# 200 Clearview Avenue

Urban Design Brief  
October 18, 2024

# Response to Urban Design Comments Received During Pre-Consultation

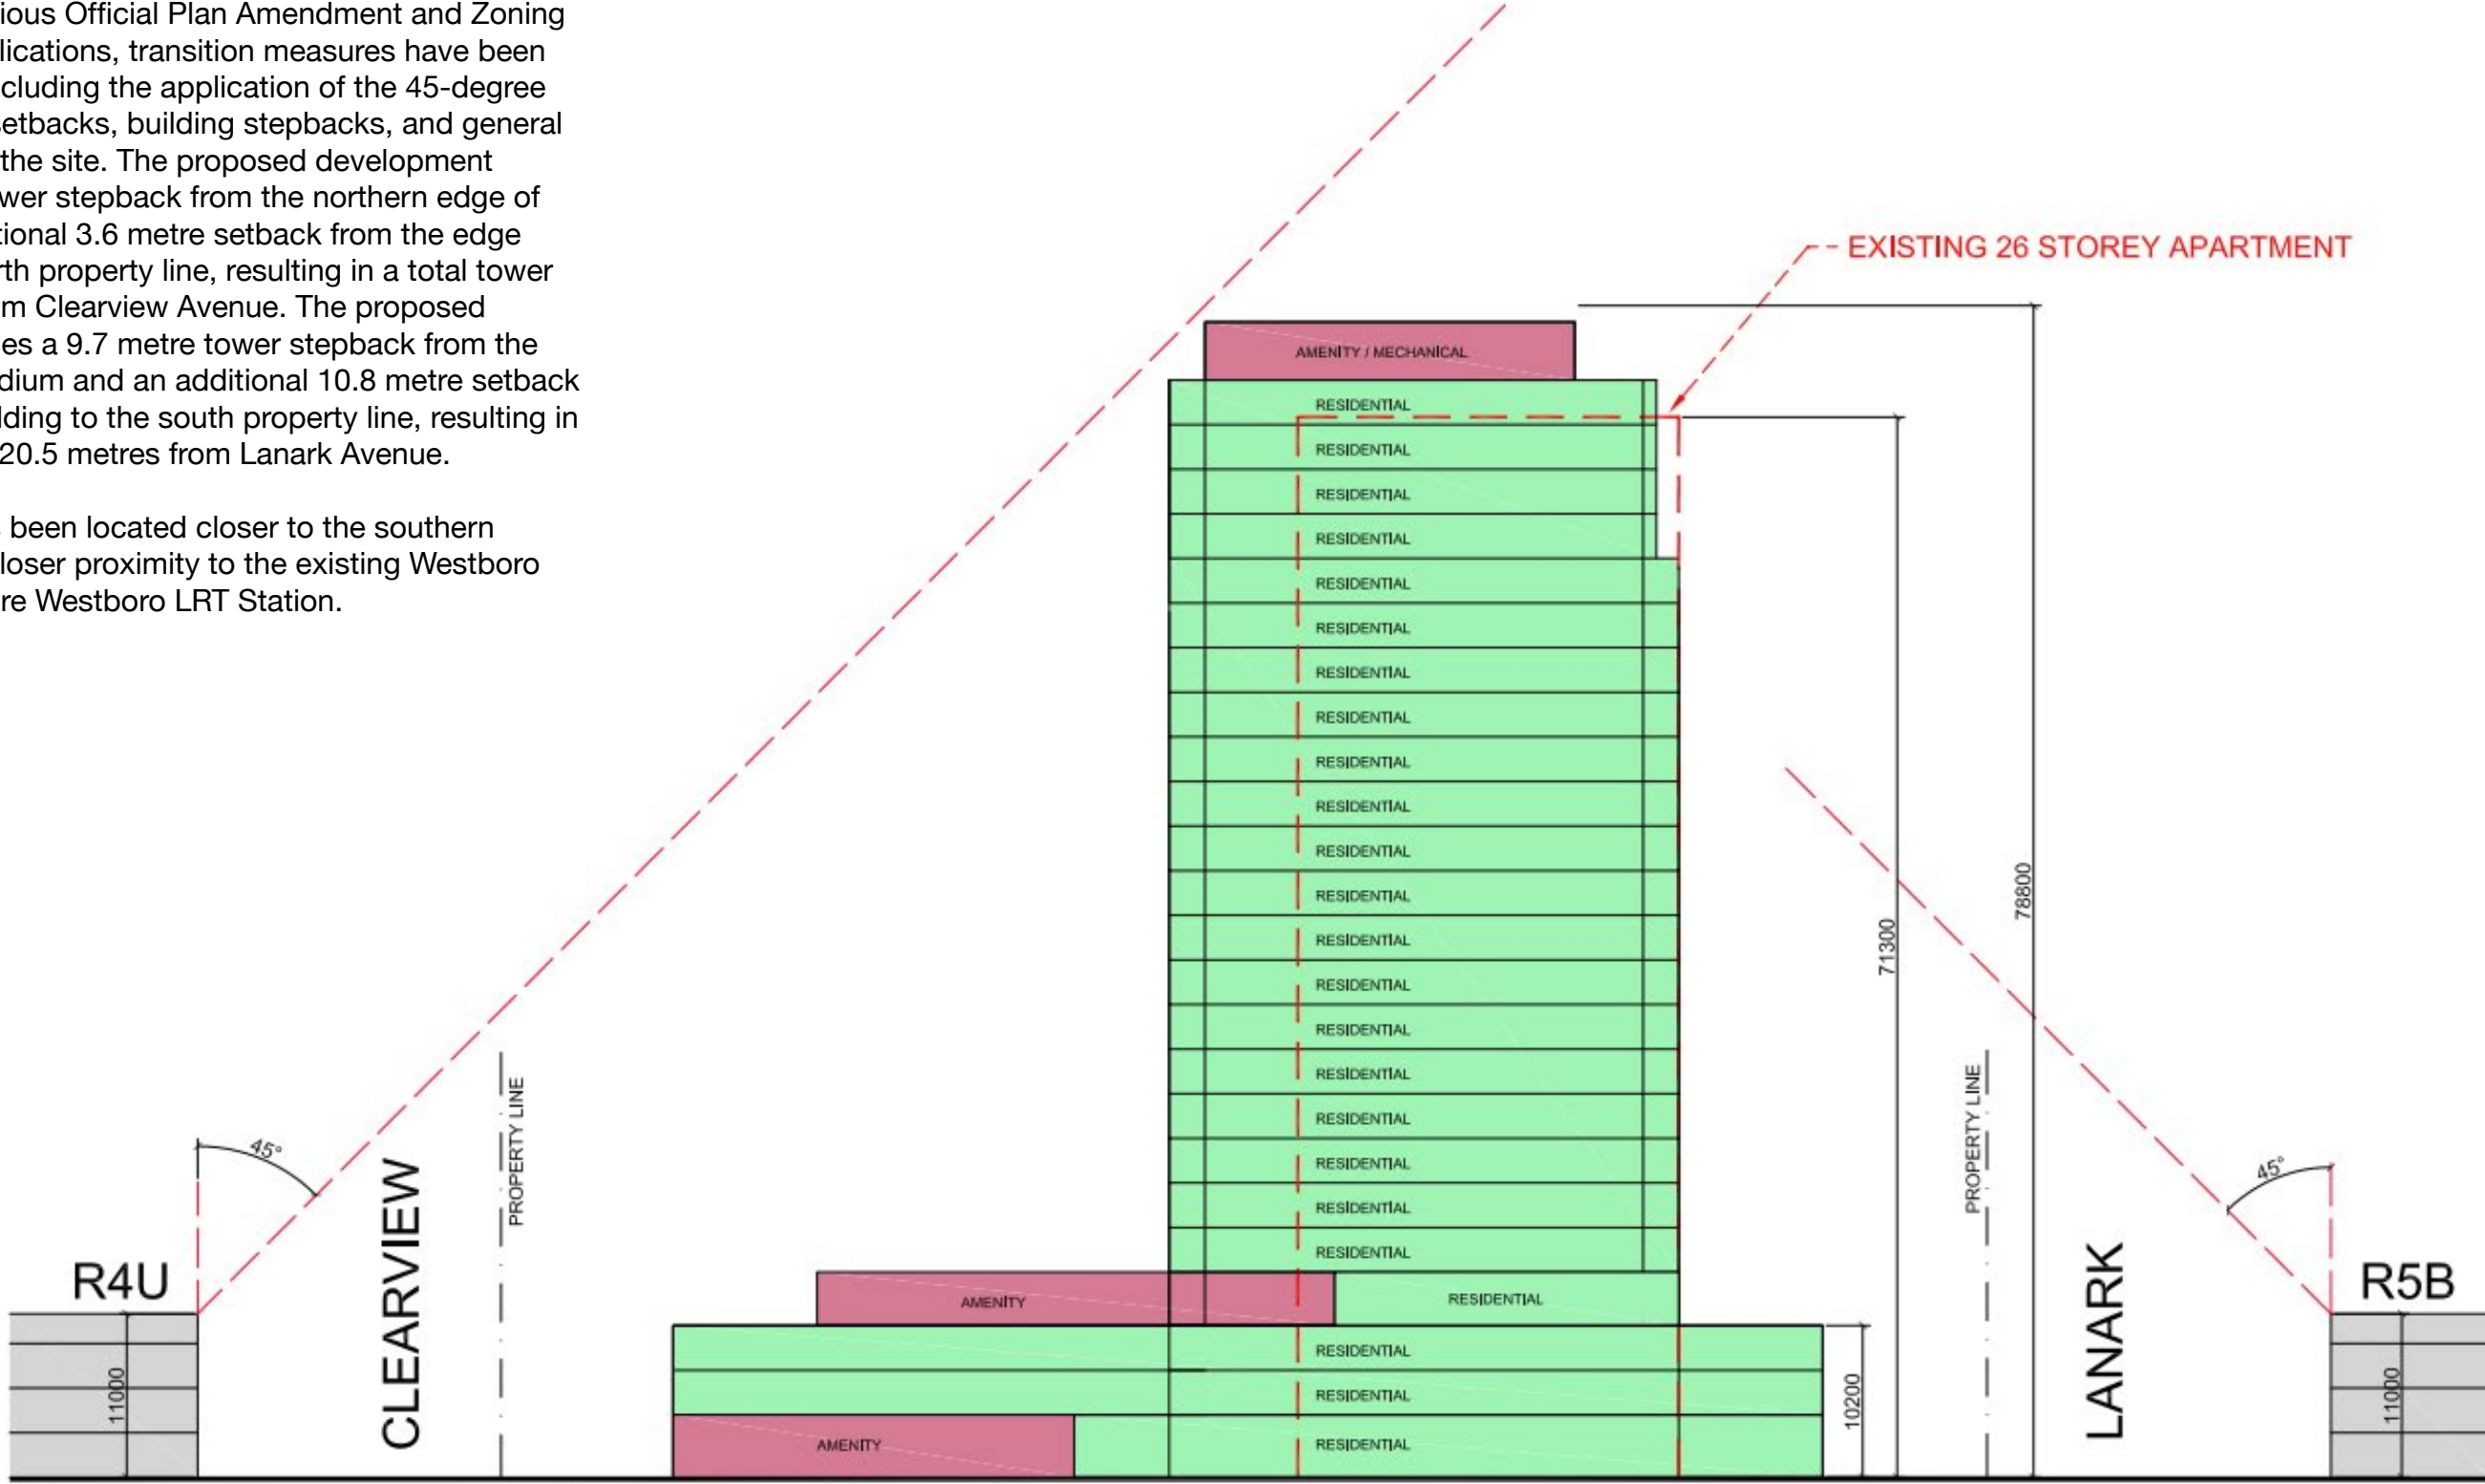
- / The Site Plan has not been updated from the re-zoning application stage, so more material needs to be submitted for us to perform a fulsome review.

- / We recommend the ground floor be detailed in the application to facilitate review of site relationships and grade related units.

**Response: A revised site plan and architectural package has been included as part of the Site Plan Control application submission. The proposed development is relatively unchanged from the proposed development that received Official Plan Amendment and Zoning By-law Amendment approval.**

**Response: As noted above, a ground floor plan is included in the architectural package to illustrate the grade-related units.**
